November 30, 1990

**SUBJECT: Grand Gulf Nuclear Station  
Unit 1  
Docket No. 50-416  
License No. NPF-29  
Response to RAI Regarding Settlement  
of Category I Structures  
AECM-90/0209**

FIGURE 1

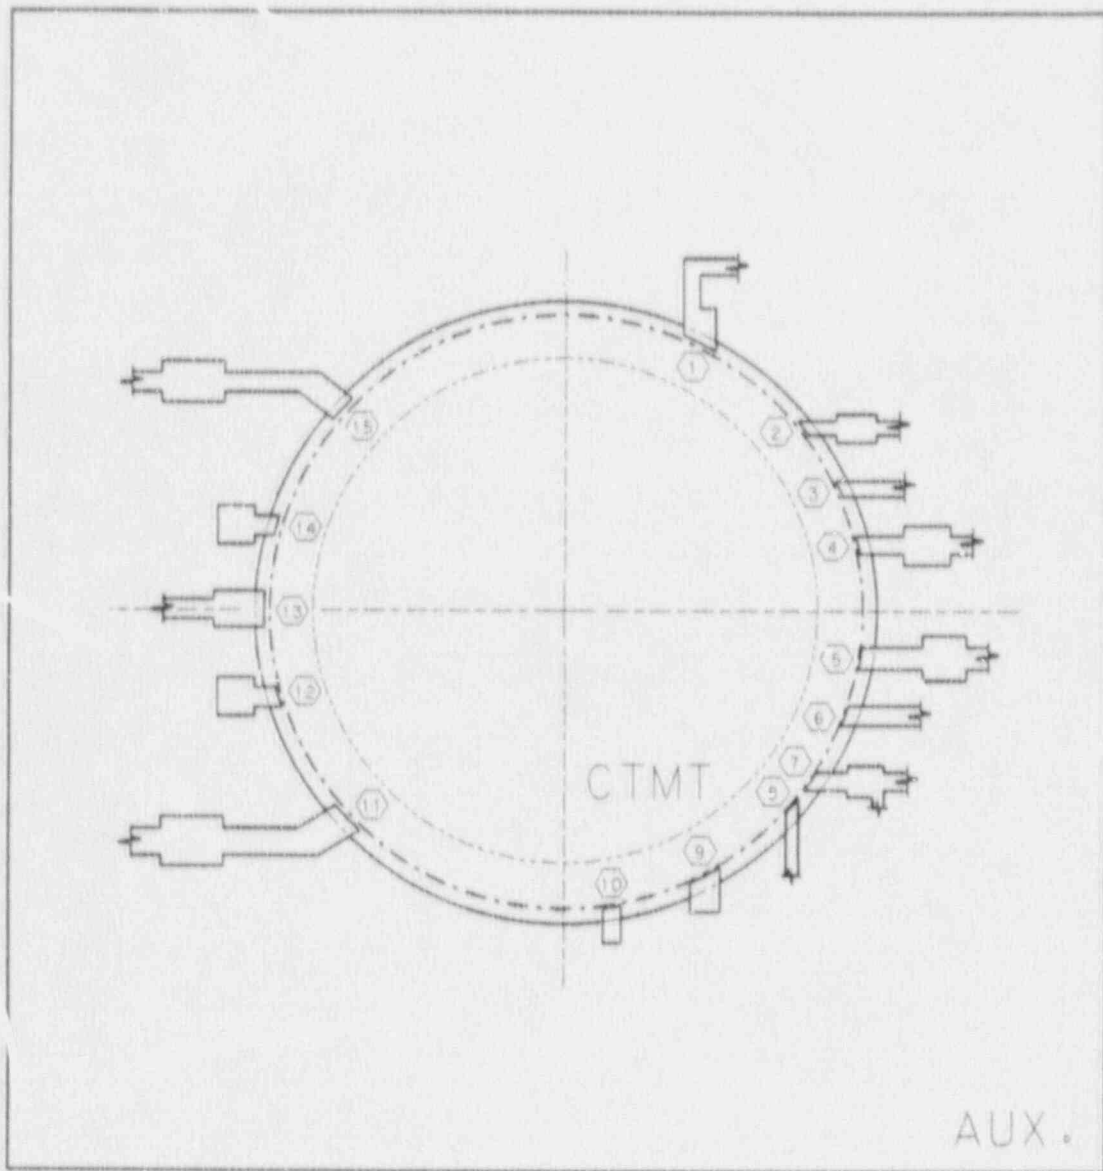
1.c) In addition to evaluating the differential settlement between adjacent structures, determine the tilting of each structure. For example, according to Fig. 2.5-75, in the updated FSAR, there appears to be a difference in settlement of about 0.6 inches between the Auxiliary Building markers P-9 and P-15 which are on either side of the Containment.

Discuss the safety significance of this differential settlement of the Auxiliary Building, as recorded by markers P-9 and P-15.

In the April 17, 1990, NRC General Site Tour, it was noted that the gap beneath an Auxiliary Building wall and the Containment base mat appeared to be missing. A subsequent investigation by Entergy confirmed that the gap was not provided in nine (9) locations (see attached Figure 1) and failed to locate existing documentation which accepted this condition. A material nonconformance report (MNCR 0048-90) was written to document and address this condition. Based on this discovery, the information provided to the NRC on April 16, 1990 which showed that the Auxiliary and Containment buildings have moved towards one another, was re-evaluated. Further investigation revealed that the buildings are actually tilting in the same direction and, since the buildings are in contact in the vertical direction, there is no differential settlement between Auxiliary and Containment Buildings. The initial error in determining the measured differential settlement was due to the method used in combining the data for Containment points 11 and 13 with the relocated Containment points 11A and 13A.

Allowable differential settlements for the Auxiliary and Containment Buildings are 1.15 inches and 0.6 inches, respectively. These values are based on maintaining a minimum clearance between buildings to preclude building contact during an OBE occurrence considering the worst case scenario of the two structures tilting toward one another along the same axis. The measured differential settlements of 0.89' and 0.33" on the Auxiliary Building and Containment, respectively, are of no safety significance since both these values are less than the UFSAR allowables and the structures are tilting in the same direction. Furthermore, field inspections of the seismic gap between the Auxiliary and Containment Buildings reveal that actual closure of the gap is not evident.

NOTE: VERTICAL SEISMIC GAP IS ABSENT AT LOCATIONS 1, 2, 4, 5, 7, 11, 13, 14 AND 15.

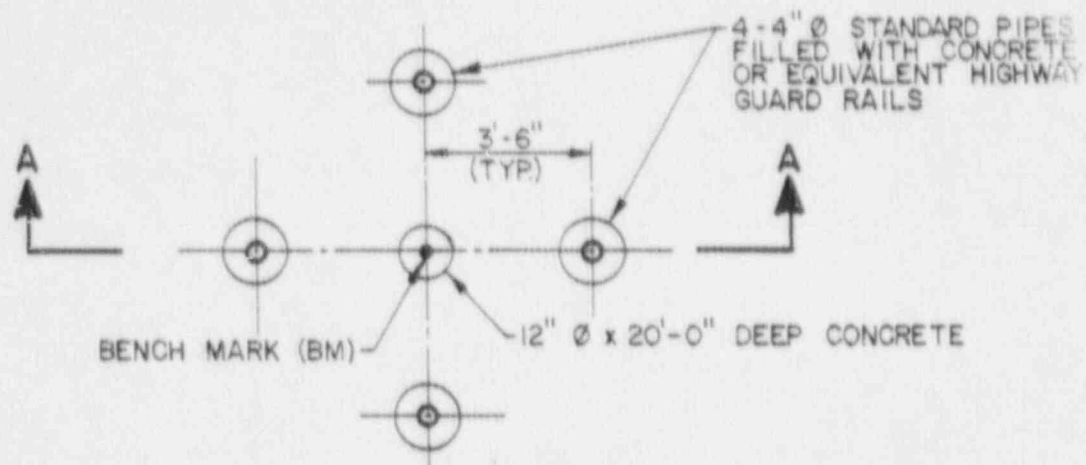
- 2.B) Describe the surveying procedures used to re-establish the destroyed settlement markers, paying special attention to:
- i) The Quality Assurance aspects of accurately transferring the settlement data from the destroyed markers to the new markers, and
  - ii) The proper maintenance and assurance of the accuracy of permanent benchmarks used in settlement monitoring.

The settlement markers were placed on columns, walls, and foundations of the various structures. Normal construction activities such as the addition of floors, walls, cable trays, or equipment would destroy or cause a marker to become inaccessible. When possible, the replaced or relocated marker was tied to the old marker using 3-wire leveling with elevation and settlement readings recorded to the nearest 0.001 foot. An adjusted initial elevation was provided for the new marker providing an uninterrupted settlement observation. Data collected was recorded in a Settlement Data Table with locations of markers shown on Drawing C-0132.

FIGURE 3

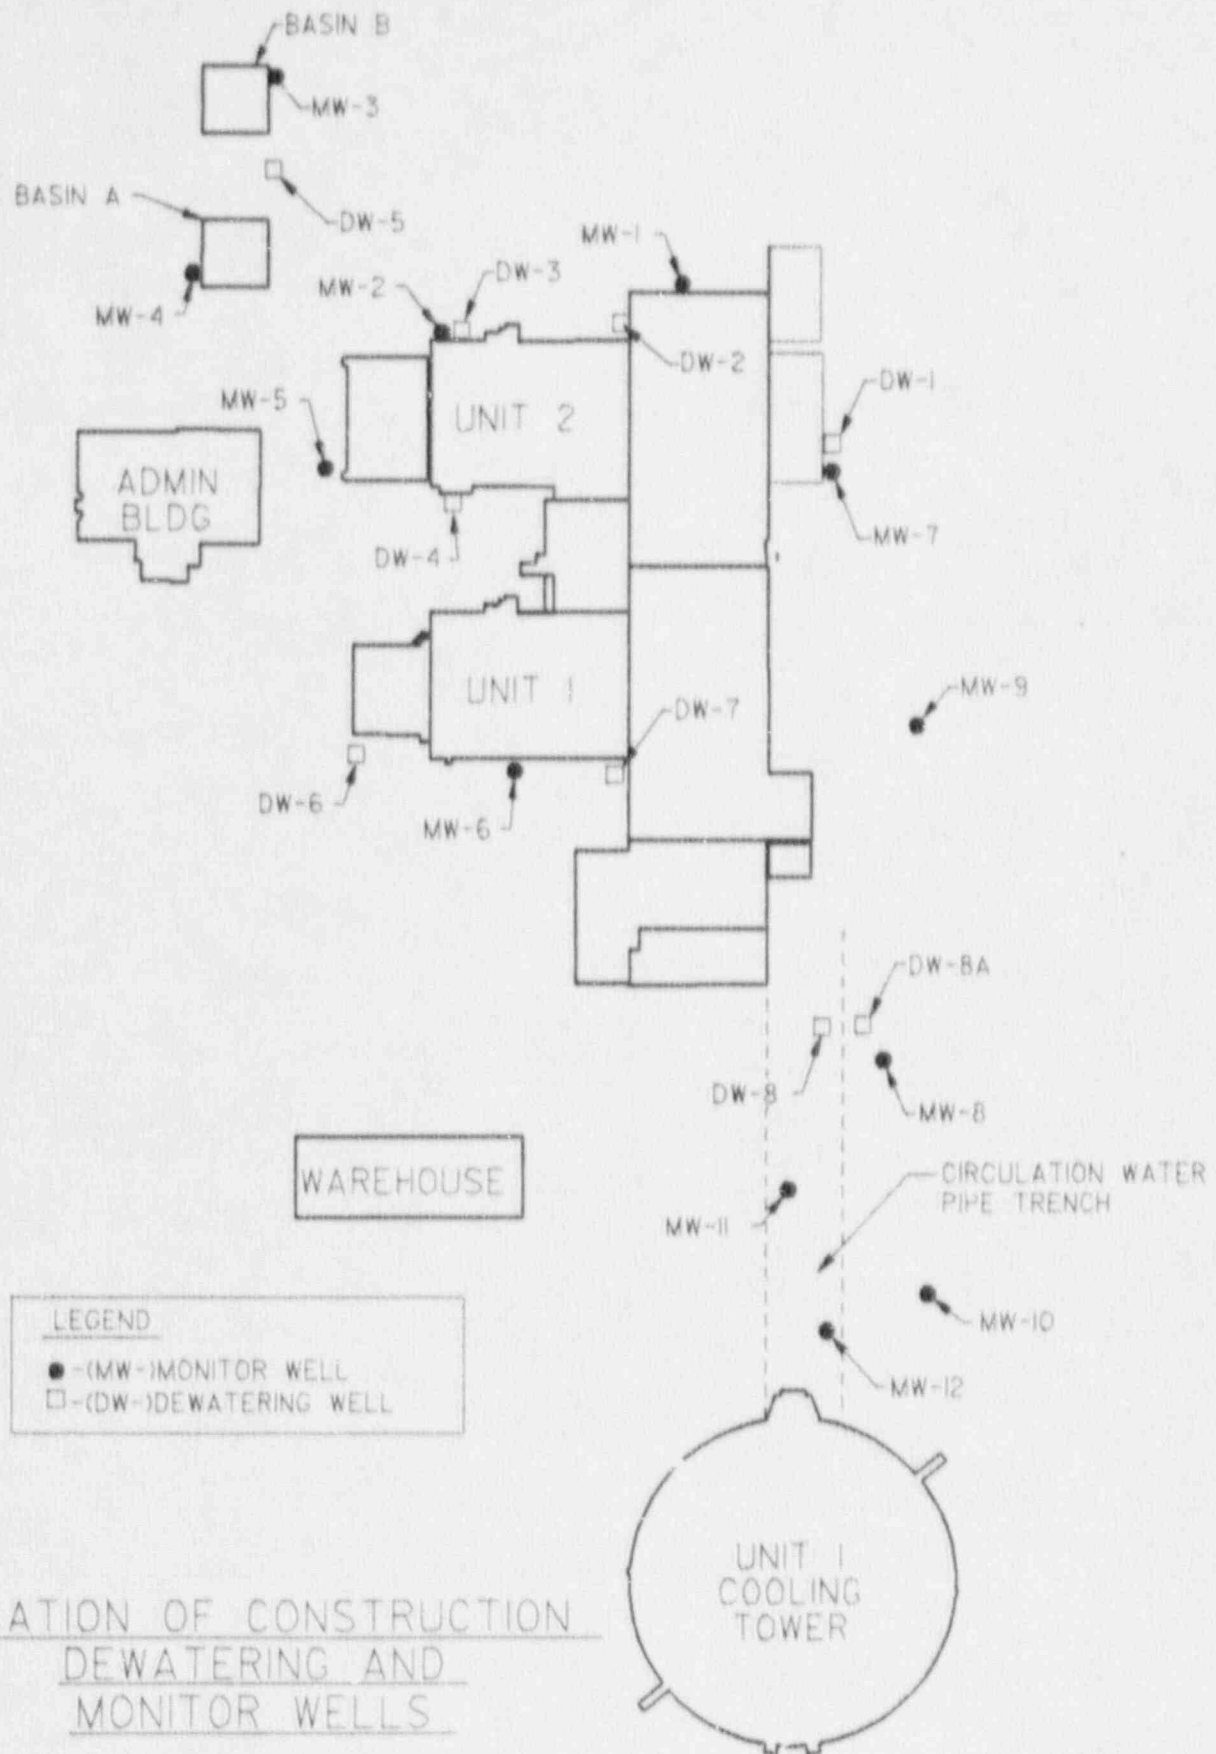
- 3.0 Discuss the results of groundwater monitoring at the site and provide an evaluation of the effects of fluctuation in groundwater level, if any, on the stability and settlement of structures.

From January through July, 1983, Well DW-8 (see Figure 3) exceeded the design maximum groundwater elevation of 109.00 ft. MSL. The highest water level recorded during this period was 110.21 ft. MSL in February, 1983. The high groundwater elevation was reported to NRC via AECM-84/0020 in March, 1984. Since this initial exceedance, there have been additional groundwater level exceedance events. These were reported in March, 1985 (AECM-85/0088), February, 1986 (AECM-86/002), March, 1986 (AECM-86/0202), March, 1990 (AECM-90/0062), April, 1990 (AECM-90/0083) and September, 1990 (AECM-90/0183).

Water levels above 109 ft. MSL have been exceeded only around DW-8 by less than three feet. Other areas around the plant have generally been within the expected range. It is therefore concluded that the minor fluctuations have had a negligible effect upon plant settlement. As noted above, a more thorough report addressing groundwater monitoring at GGNS will be completed by the end of December, 1990.
